Product Change Notice

Issue Date: 03-December-2021

Change of packing location

Current:

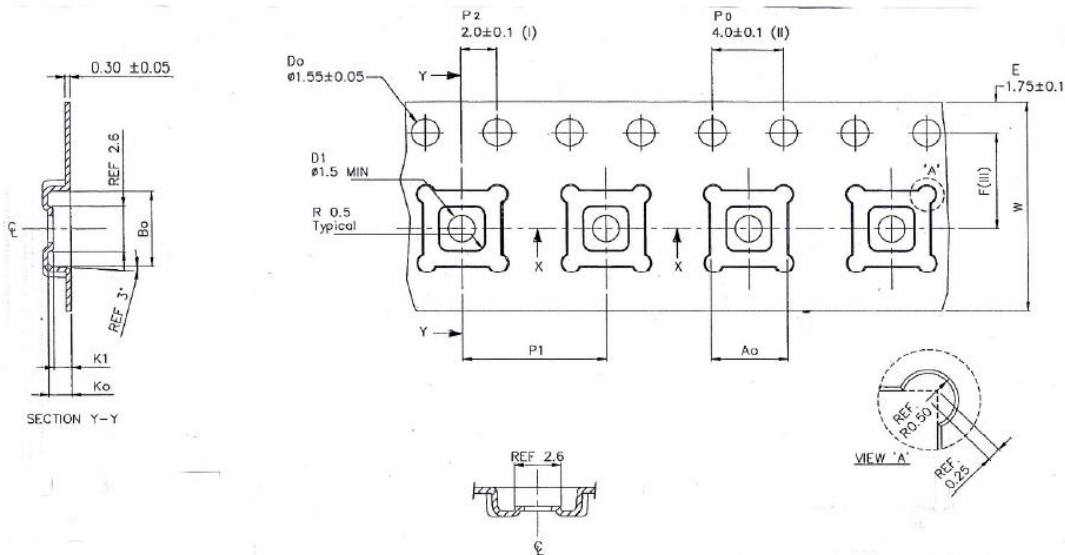
Change of packing location from UK to Germany. Minor changes in the reel-dimensions, for details refer to the following drawings (all dimensions in mm).

DIMENSIONS	
Ao	4,35 ±0,10
Bo	4,35 ±0,10
Ko	1,10 ±0,10
P	8,00 ±0,10
T	0,30 ±0,05
W	12,00 +0,30/-0,10

New:

A_0	=	$4,30 \pm 0,10$	K_1	=	$1,00 \pm 0,10$
B_0	=	$4,30 \pm 0,10$			
K_0	=	$1,30 \pm 0,10$			
P_1	=	$8,00 \pm 0,10$			
W	=	$12,00 \pm 0,30$			
t	=	$0,30 \pm 0,05$
